January 2022 | Danfoss Climate Solutions for cooling

TECH
INSIDER

Improvement of VZH117 Power Connection

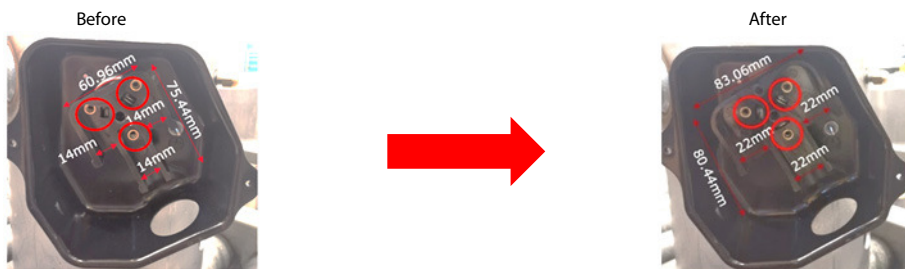
To improve the VZH117 voltage code J power connection, Danfoss has recently changed the "T-Block" to a larger size, allowing more space to fit power cables and terminals.

The "T-block" is used in compressor electrical boxes for connecting the power supply.

The bigger size now implemented is providing more space for cable connectors and will ease assembly of "2 AWG" cables size on VZH117 voltage code J, as we recommend in the application guideline.

The VZH117 code J new T-block is fully interchangeable and was implemented in October 2021.

New Accessory ICAD -UPS (Uninterruptible Power Supply) – Replacing Current Code Number

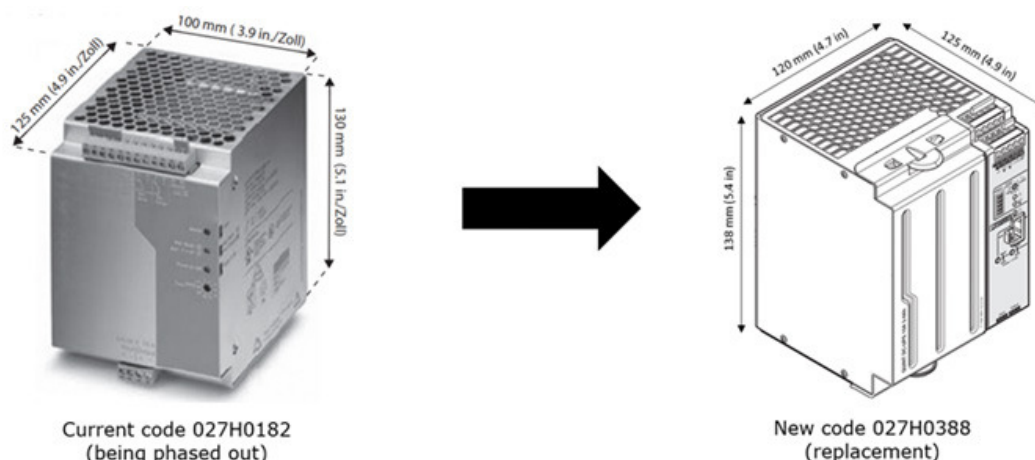
We are pleased to announce the introduction of a new code number for the UPS for ICAD that will be replacing the current accessory code number 027H0182.

The new ICAD-UPS (code 027H0388) delivers all functionality and capacity of current code; and it can replace current code in new installation as well as a retrofit. The new code has been fully validated and it is available for ordering.

Moving forward previous code 027H0182 will be discontinued, so new orders for the accessory must be transferred to the new code 027H0388.

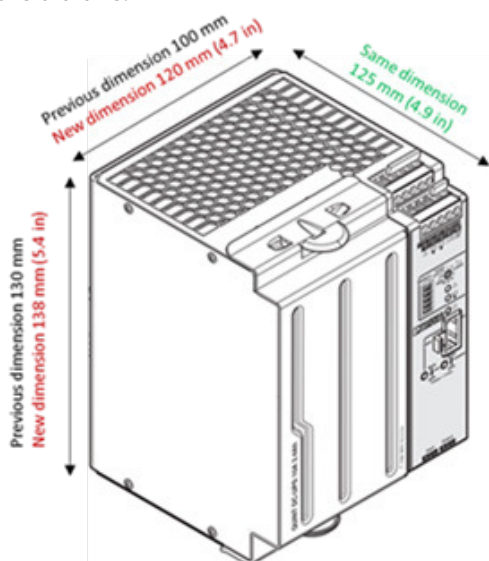
One consideration to be aware of is the small difference is some of the external dimensions of new UPS compared to the old one.

All details regarding dimensions and installation of new ICAD-UPS can be found in the **installation guide**

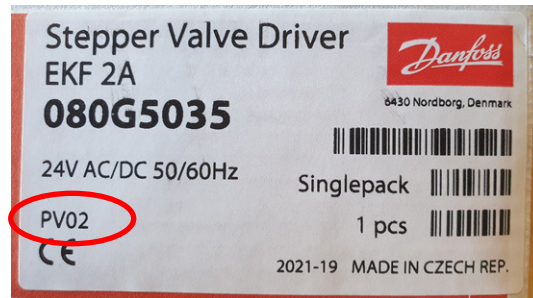
2.
EKF PV02 SW1.24 has now been UKCA approved, and the marking is visible in the installation guide.
